CHANGES TO PROJECT DRAWINGS:

PROJECT: *Beatrice State Developmental Center - Central Heating Plant Upgrades*

DESCRIPTION: Addendum #2

PIPE MATERIAL AND INSULATION GENERAL NOTES

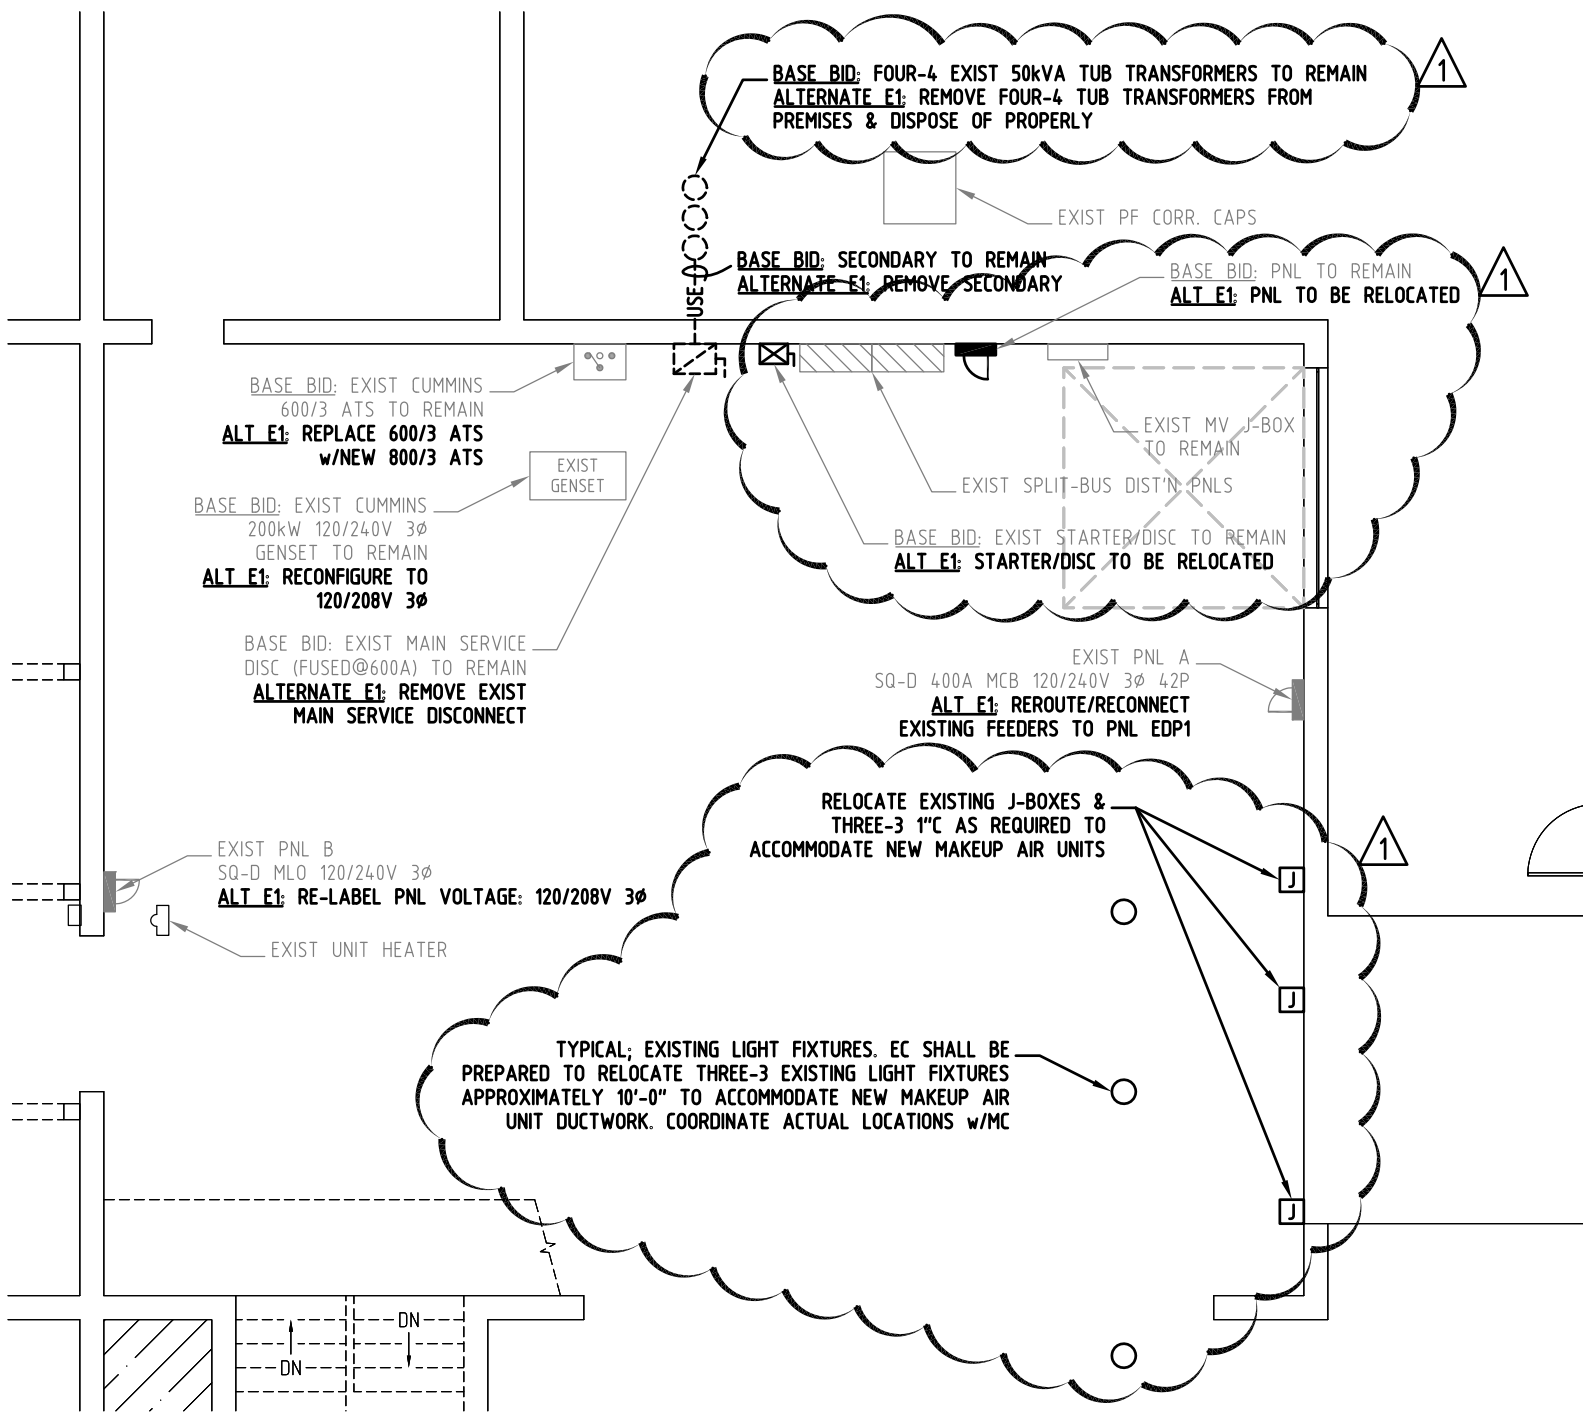
- 1) Add Note 6, it shall read "All gas piping with gas pressure greater than 5 psi shall be continuously welded for all sizes". Note 6 shall apply to all gas piping.
- 2) Steam condensate return piping and fittings shall be fiberglass reinforced piping for sizes 1" and up.
- 3) Add a steam condensate piping line for sizes ¾" and less. Material shall be schedule 40 black steel

- 4) Under first bullet in valve schedule notes, part of note shall read ".....Central Plant shall be lockable valves with lock out tag out in all steam,"
- 5) Chemical feed piping line shall read "All Sizes" under Pipe Size column.
- 6) Add a line for flue condensate piping, it shall be copper
- 7) See ADD02.M51-1 for changes.

- ALL VALVES SERVING DEAERATOR (BFDA-1), BOILERS (BL-1, BL-2 & BL-3), EXISTING SURGE TANK, MAU-1, MAU-2, AND DWHS IN BUILDING #25: CENTRAL PLANT SHALL BE LOCKABLE VALVES WITH LOCK OUT TAG OUT IN ALL STEAM, CONDENSATE, GAS, BOILER FEED WATER, AND BOILER BLOW DOWN PIPING.

FIRST FLOOR DEMOLITION PLAN

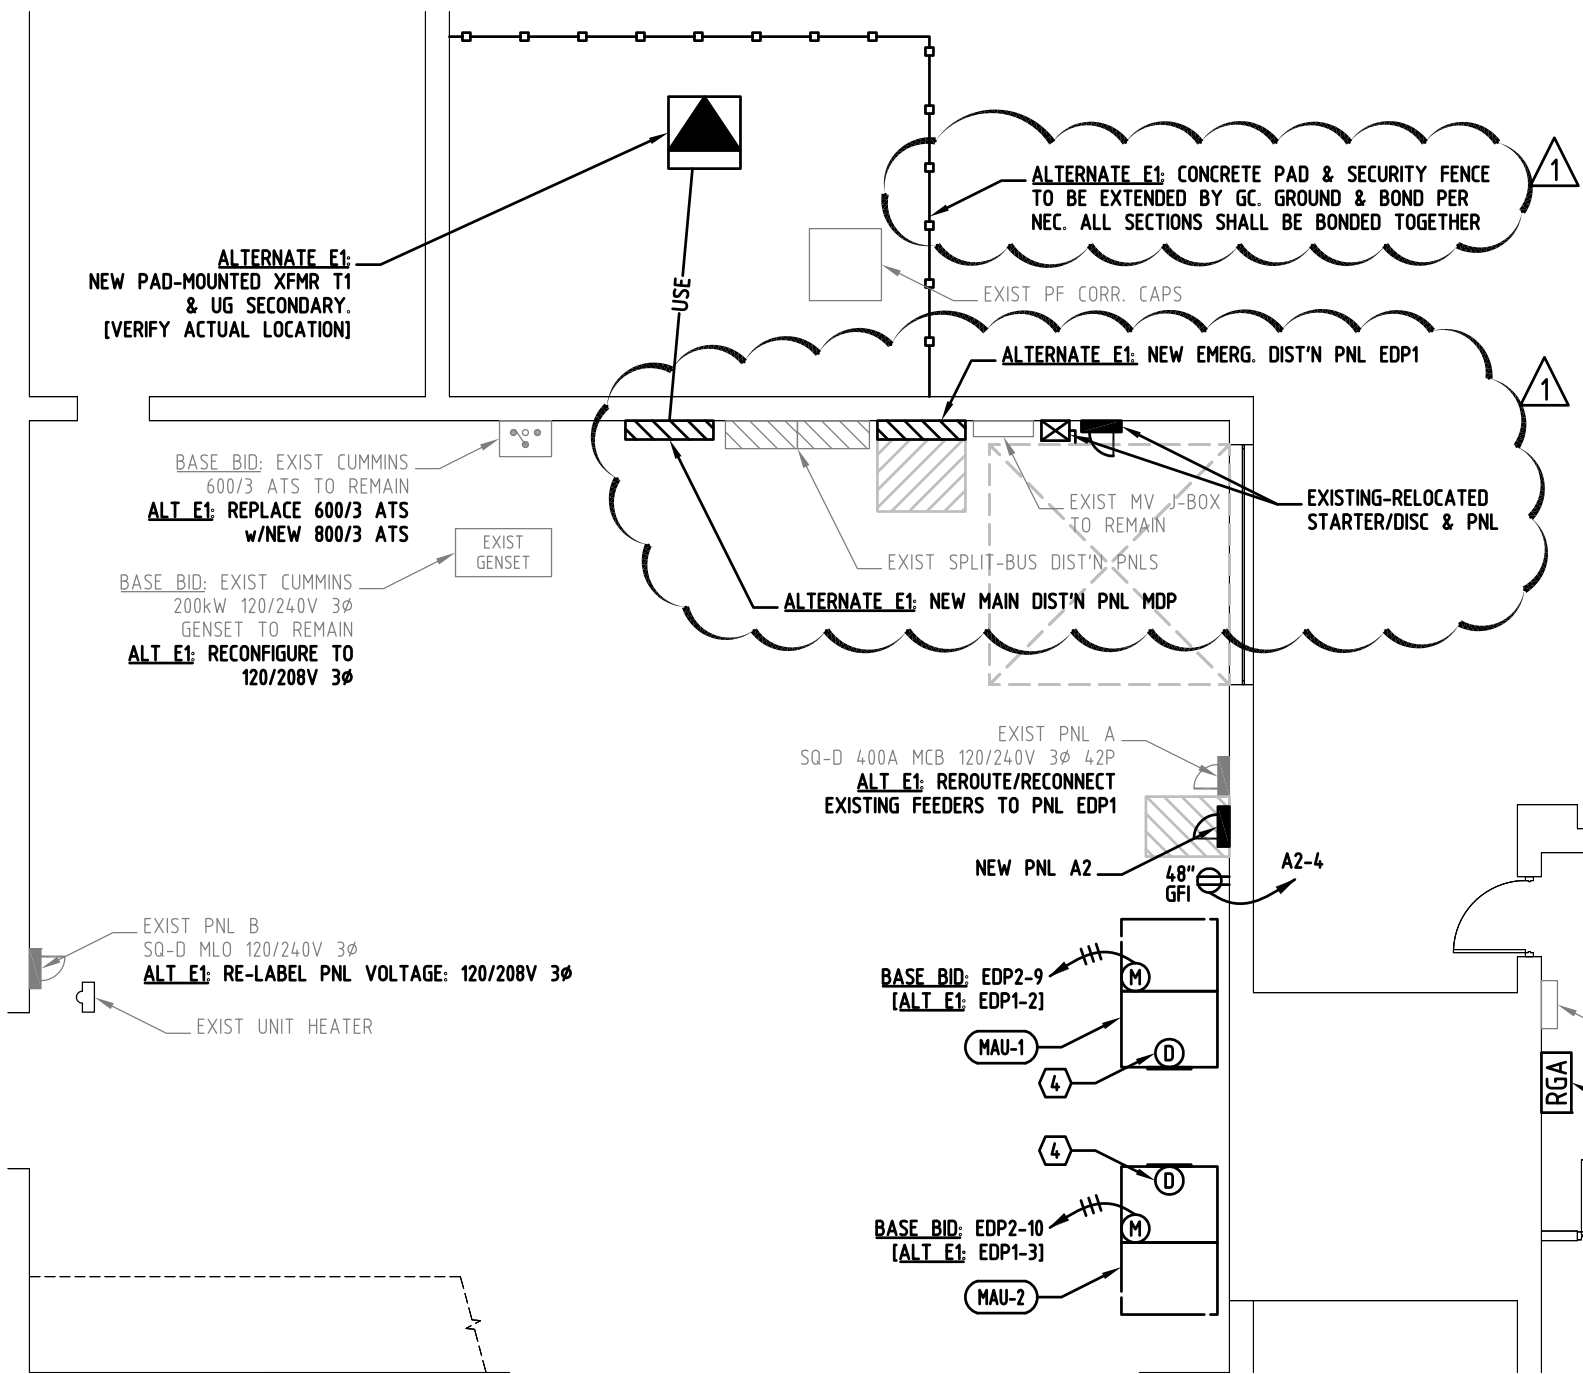
- 1) Under Alternate-E1; at the location to the three-3 50kVA tub transformers, there is a 4th 50kVA tub transformer that is not connected but shall also be removed along with the other three-3. These four-4 transformers are to be removed from the campus premises & disposed of properly.
- 2) Under Alternate-E1; existing starter/disconnect & panel adjacent split-bus distribution panels shall be relocated; see attached drawing ADD02.25E10-1&2.
- 3) Relocate existing j-boxes & three-3 1"C as required to accommodate new makeup air units; see attached drawing ADD02.25E10-1.
- 4) EC shall be prepared to relocate three-3 existing light fixtures [approximately 10'-0"] to accommodate new makeup air unit ductwork. Coordinate actual locations w/MC. See attached drawing ADD02.25E10-1.
- 5) Revise keynote 8; 'Remove existing light fixture. Maintain existing circuitry/switching to remaining fixtures'.

ADD02.25E10-2

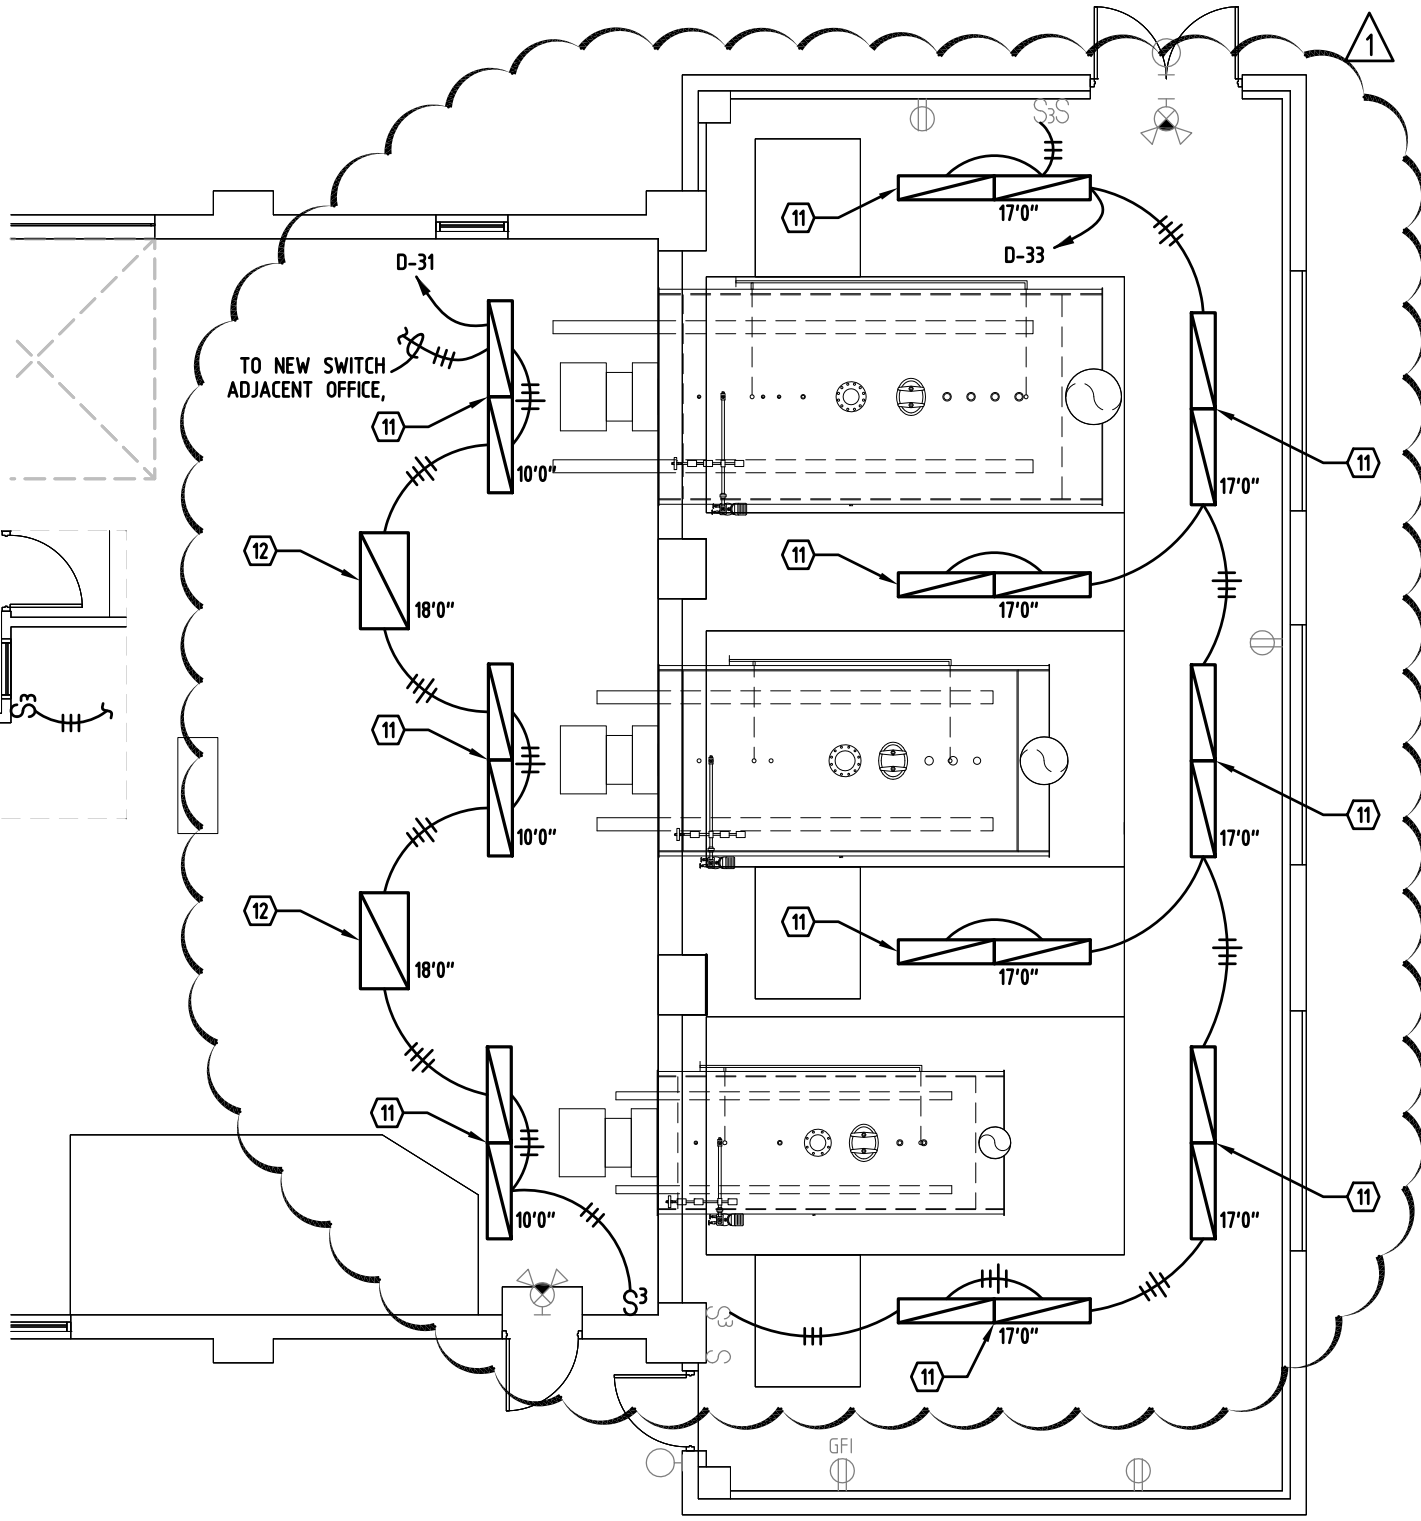
- 2) Under Alternate-E1; relocate main distribution panel 'MDP' & emergency distribution panel 'EDP1'; see attached drawing ADD02.25E10-2.
- 3) Add keynote 11; 'Furnish/install new general purpose industrial fixture; mftr: Lithonia TEJSA 2 32 MVOLT GEB10IS WGL [or equal]. Chain-hang fixtures at height noted or high as possible, coordinate actual locations w/mechanical systems'. See attached drawing ADD02.25E10.3 for locations & circuit as shown.

- 4) Add keynote 12; 'Furnish/install new fluorescent high bay fixture; mftr: Lithonia IBZ 454L MVOLT HBBS36 WGIBZ14 [or equal]. Chain-hang fixtures at 18'-0" or high as possible, coordinate actual locations w/mechanical systems'. See attached drawing ADD02.25E10.3 for locations & circuit as shown.
